**THE METROPOLITAN DISTRICT  
HARTFORD, CONNECTICUT**

**SPECIAL DEVELOPMENT DISTRICT AND ZONE  
CHANGE REQUEST FOR SOUTH TUNNEL ACCESS  
SHAFT AT 1 CHARTER OAK BOULEVARD IN  
TOWN OF WEST HARTFORD**

Re: Special Development District and Zone Change Request Application #144  
Metropolitan District Commission (MDC) in conjunction with the South Hartford  
Conveyance and Storage Tunnel Project.  
**Supplemental Project Information and Request**

DOCUMENT REVIEW COMMENTS			
Job No.: <b>60287608</b>	Title: <b>West Hartford Zone Change/SDD Request</b>	Date: <b>7/16/15</b>	
Preparer: <b>James Sullivan</b>	Reviewer: <b>Town of West Hartford</b>	Responder: <b>Various/Below</b>	
Discipline: <b>MDC South Tunnel - All</b>	Status:	<input type="checkbox"/> Criteria <input type="checkbox"/> 100% <input type="checkbox"/> 90%	<input type="checkbox"/> 60% <input type="checkbox"/> 30% <input checked="" type="checkbox"/> <b>SDD and Zone Change Application</b>
REVIEW PURPOSE:	<input type="checkbox"/> Independent Peer Review <input type="checkbox"/> Discipline <input type="checkbox"/> Project Approach Review	<input type="checkbox"/> Interdiscipline <input checked="" type="checkbox"/> Other	Action Code:

PLAN NUMBER  
SHEET NO.  
**230 C-106**

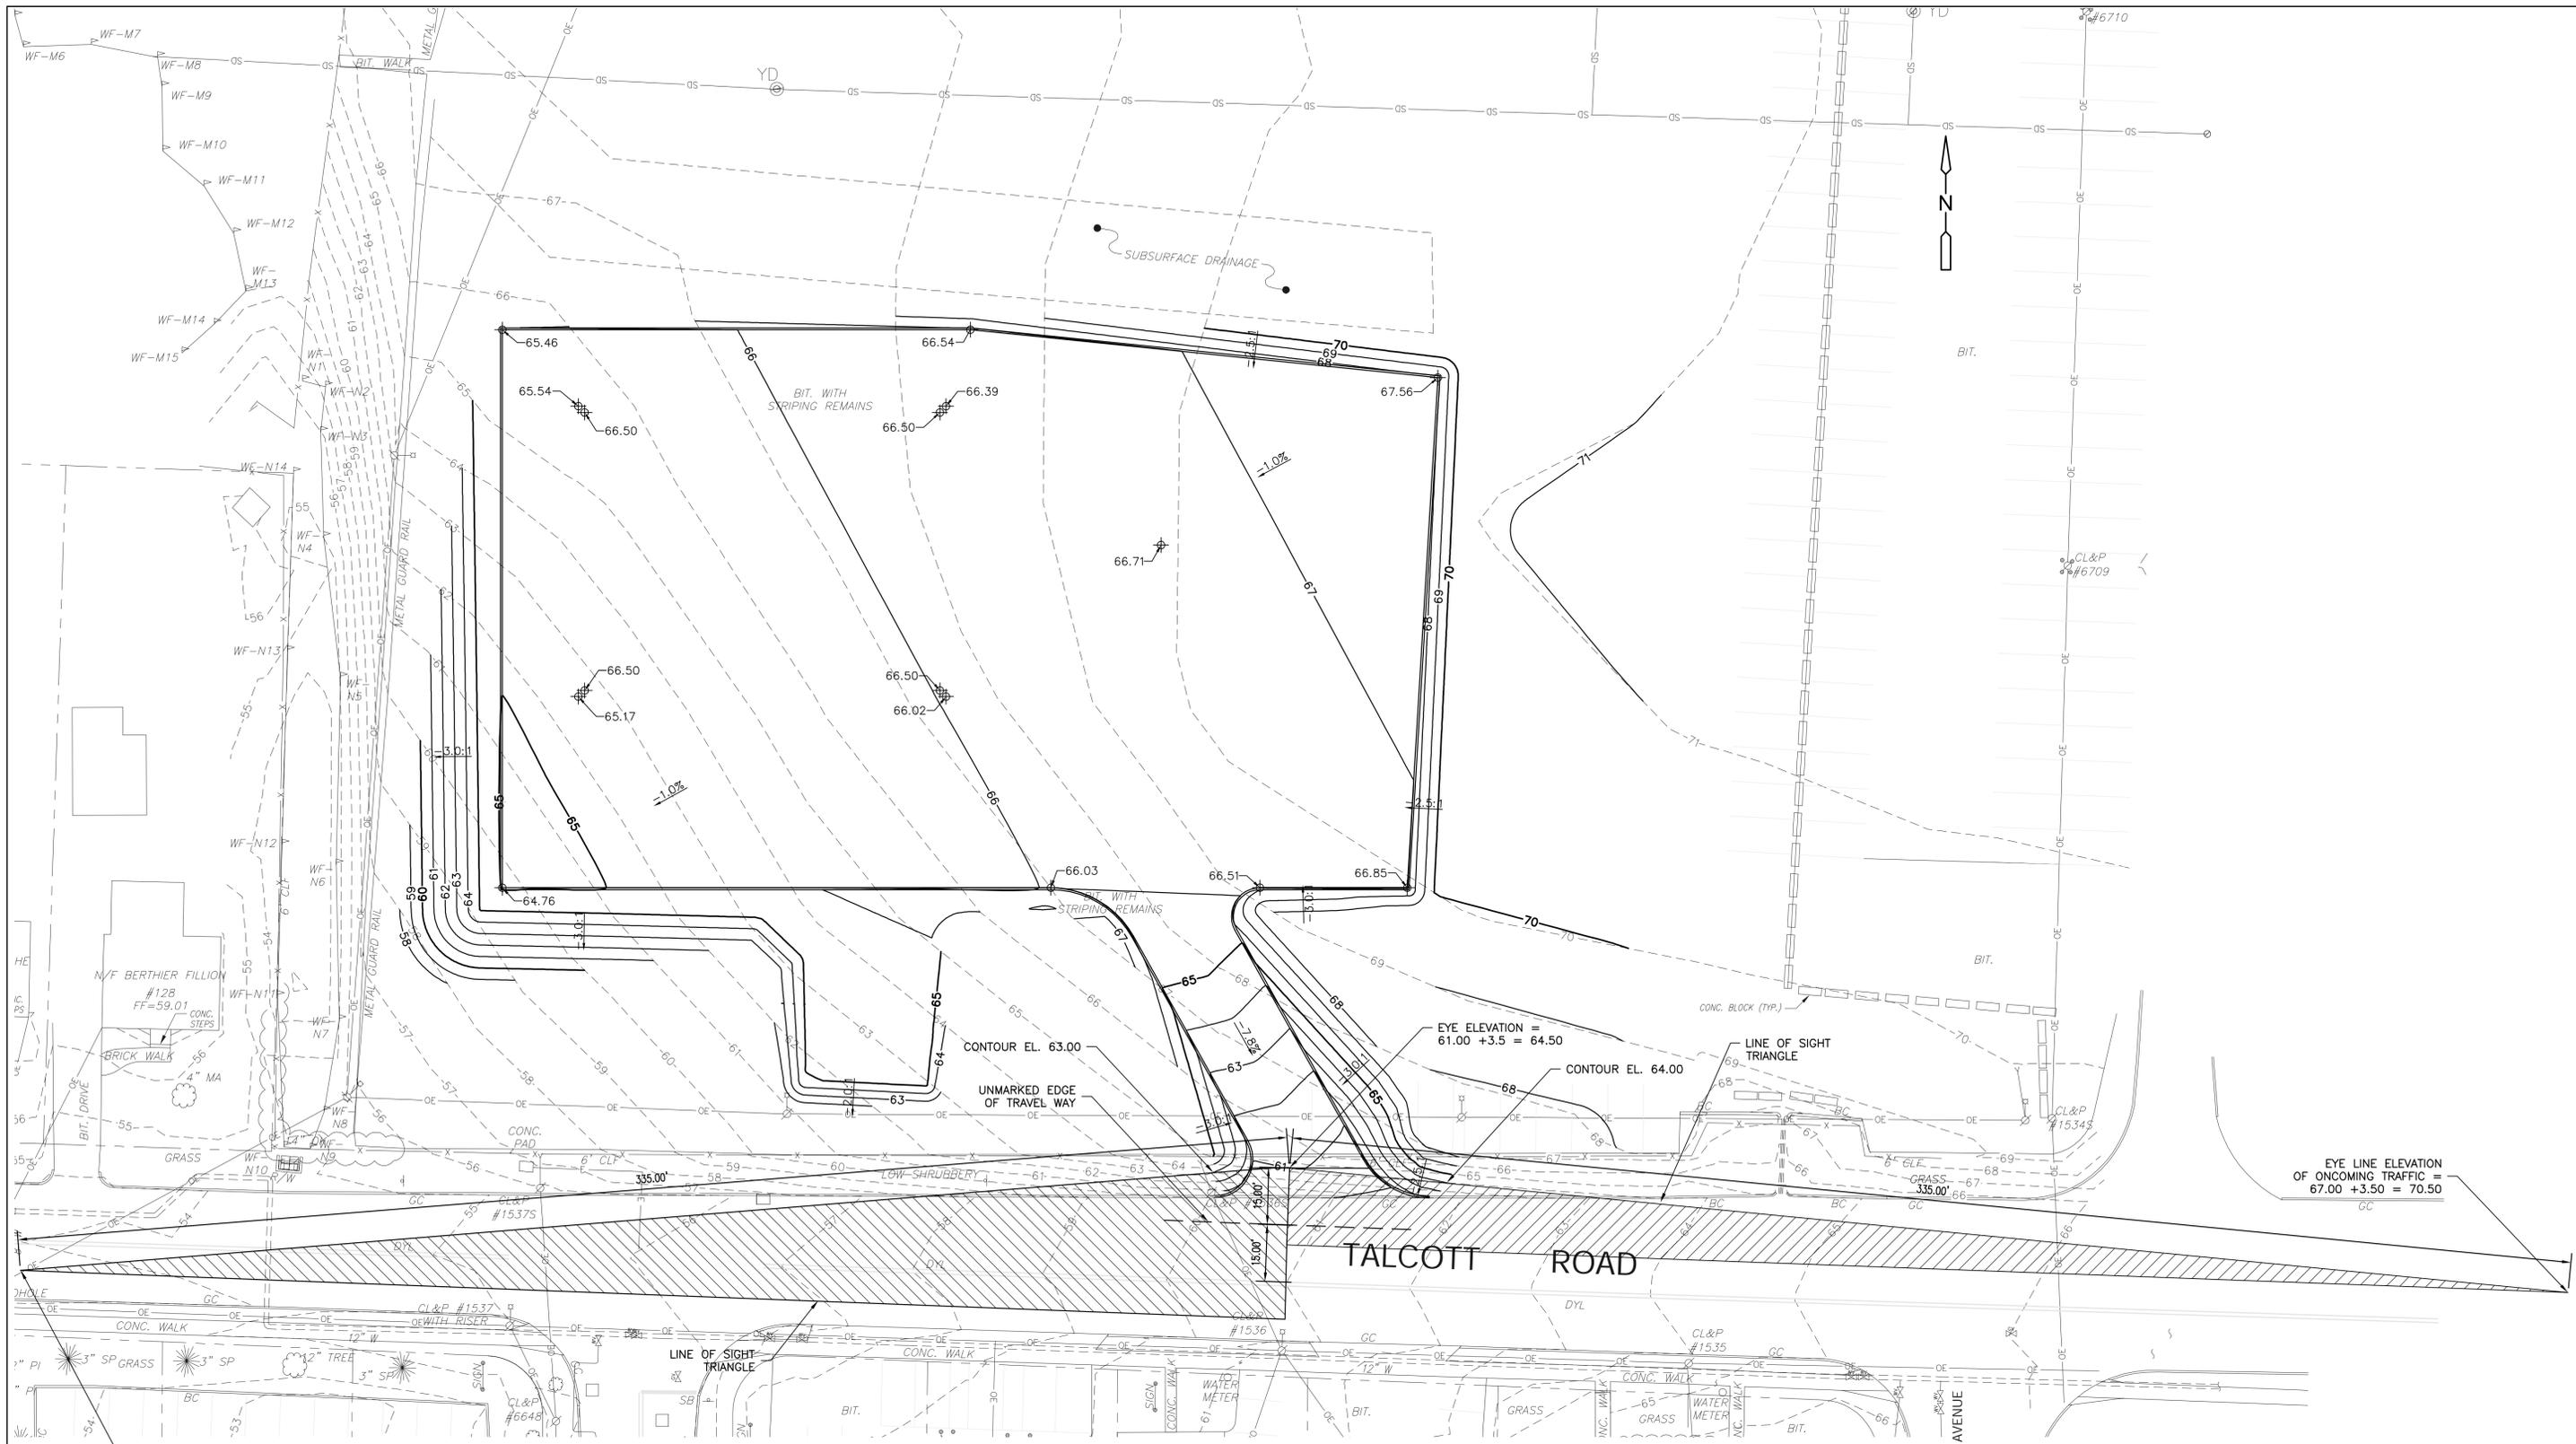
E-2	Show the intersection sight distances on the plan for the proposed site driveway for both directions. Additional grading and/or retaining walls may be necessary particularly to the east side of the driveway.	We have developed Sheet 230-C-107 in the modified plan set (Enclosure F) that shows the anticipated sight distance and the design assumptions. We believe we meet ConnDOT standards for sight distance in both directions. As discussed at the meeting with the Town Engineer on 7-16-15, we will add a single white edge of travel way to the Westbound travel lane.
E-3	How many heavy vehicles are estimated to access the site during construction and after the facility is operational?	During construction, the truck traffic could result in a truck every 10-15 minutes during the peak. This is not anticipated to have any impact on traffic flow in the area. During operation of the facility, one MDC maintenance vehicle per week is anticipated. Once every 10-15 years, the tunnel will require a tunnel cleaning operation that will be staged at this location. This would require more vehicles during the limited days of the operation, currently estimated to be 30-40 vehicles/day and the cleaning could take several weeks.

PLAN NUMBER  
SHEET NO.  
**230 C-107**

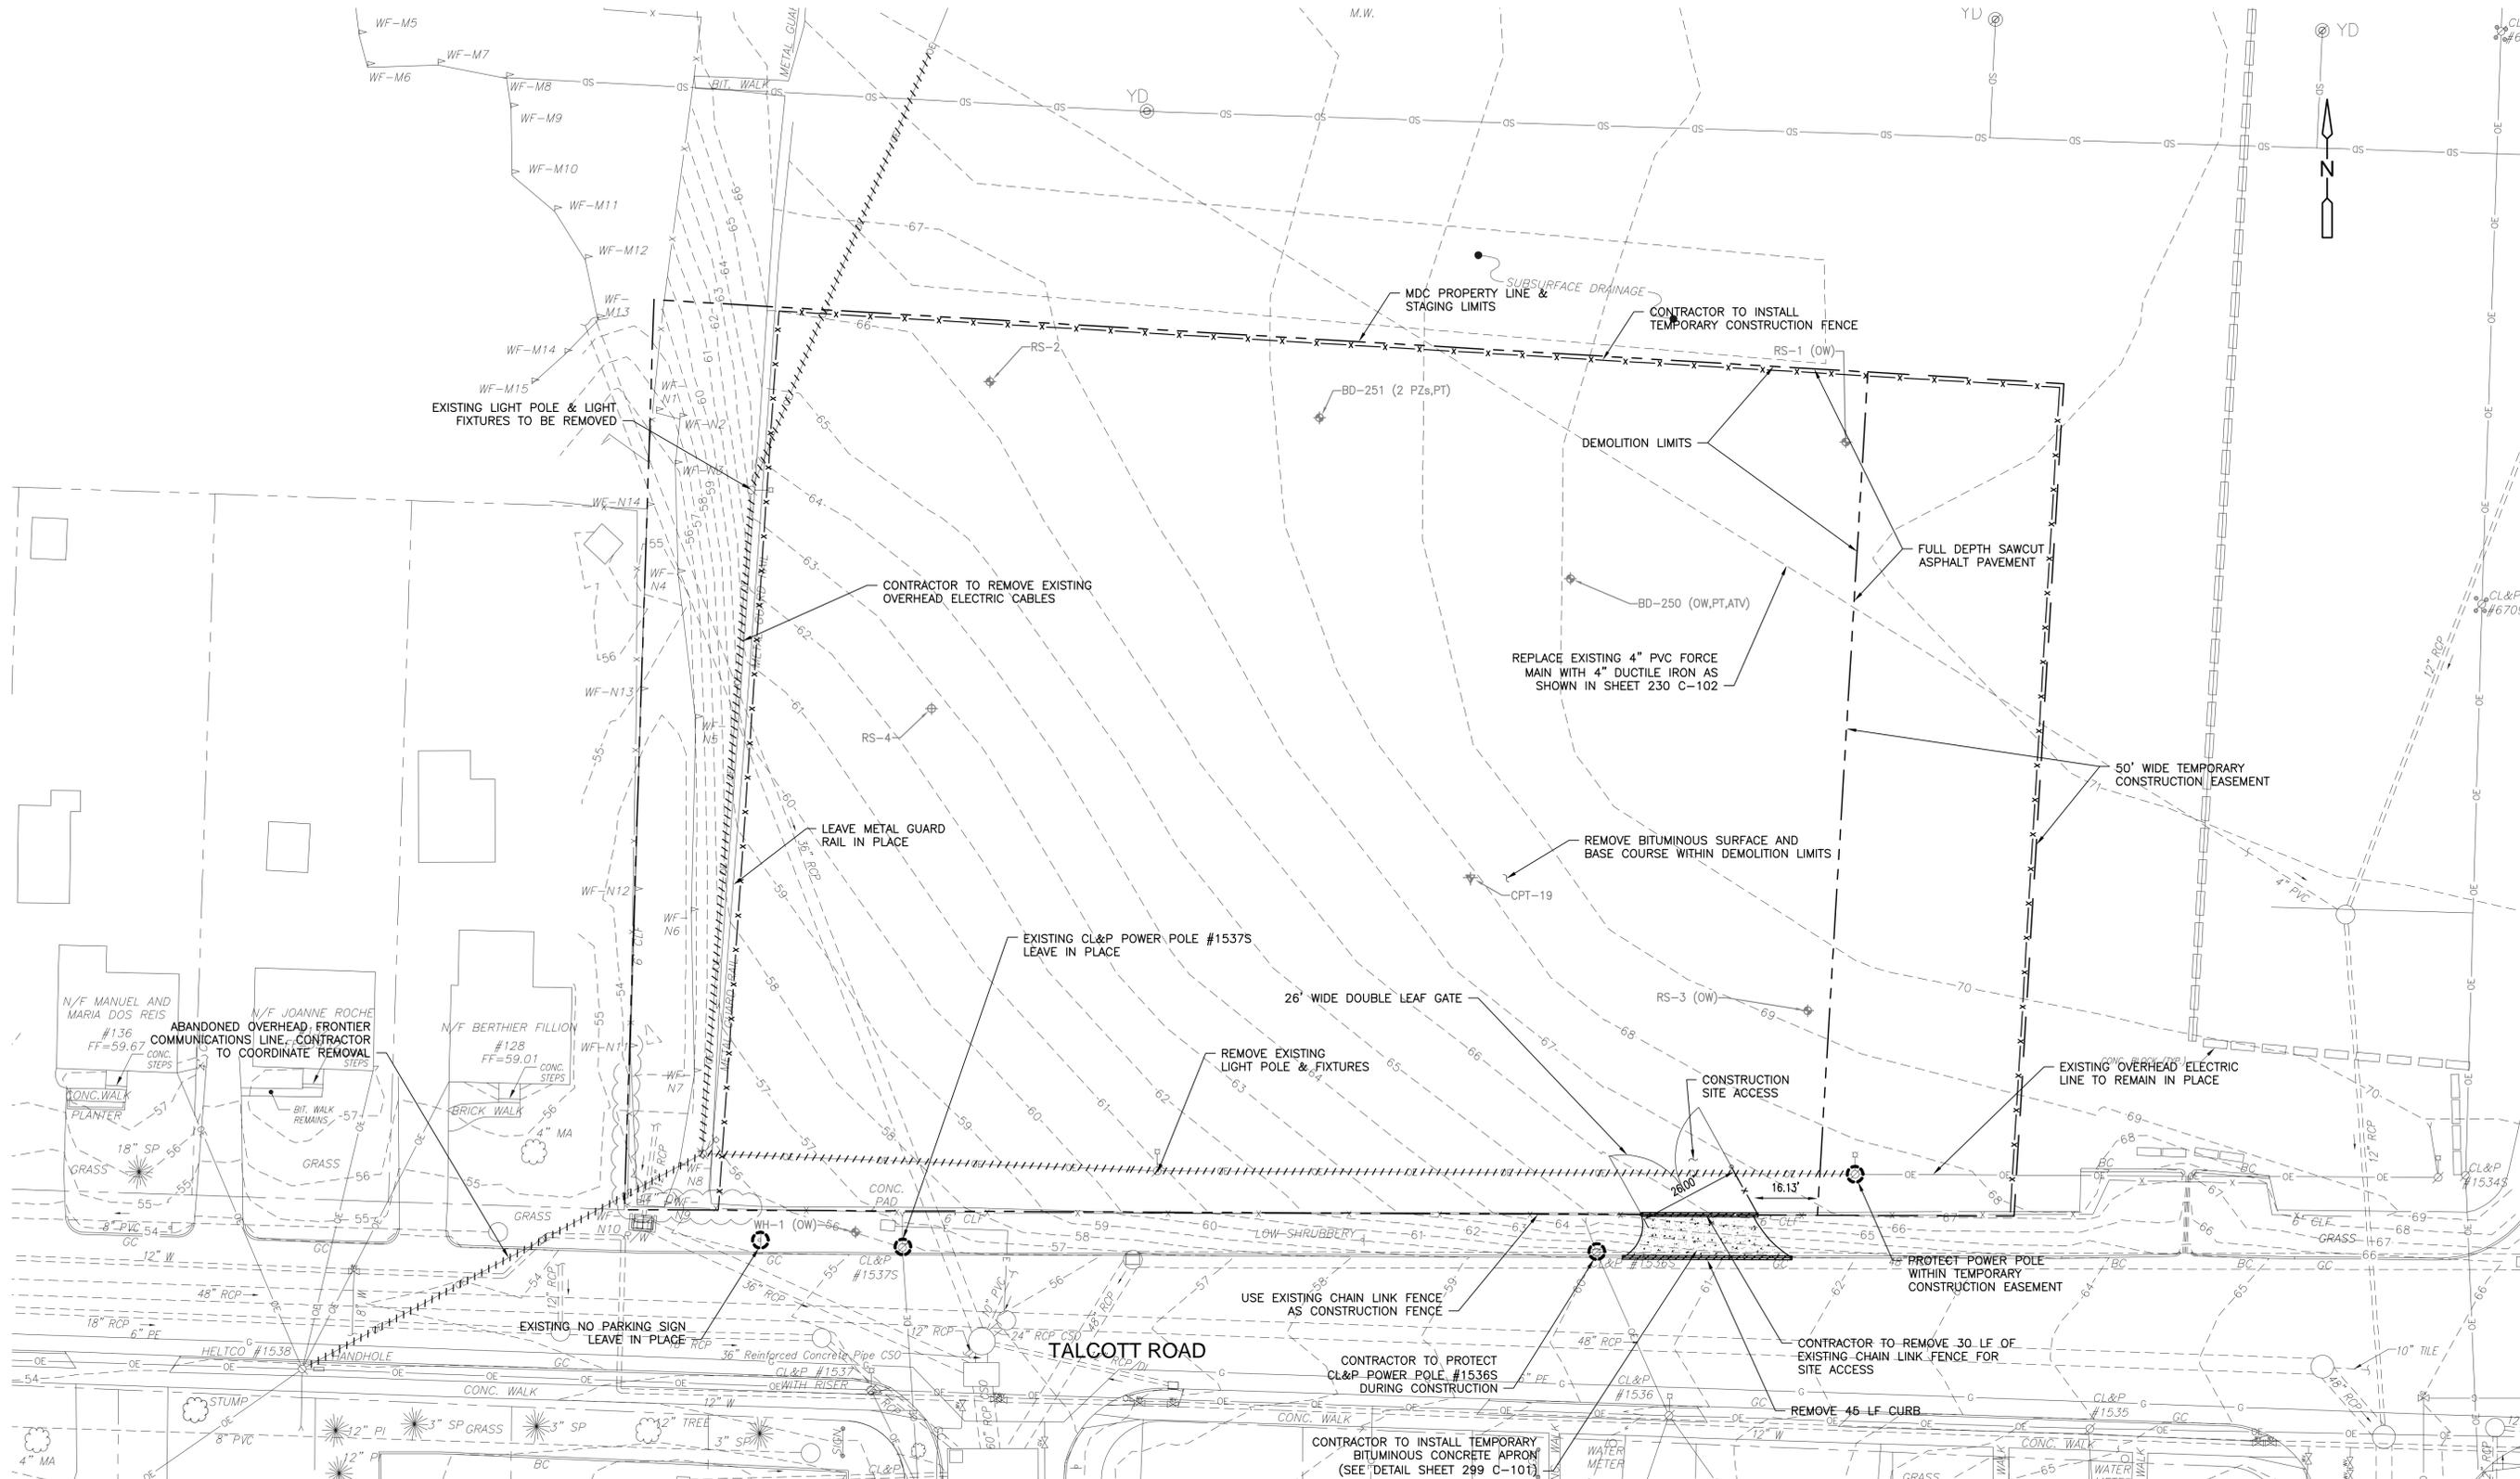
E-13	Reference is made in the plan set to sheets that are not included in the plan set.	Additional sheets have been added to the modified plan set (Enclosure F).
E-14	Driveway apron within the street right-of-way should be all pavement, no gravel.	The temporary construction entrance detail on Sheet 230-C-111 (Enclosure F) has been updated to reflect pavement in the street ROW.
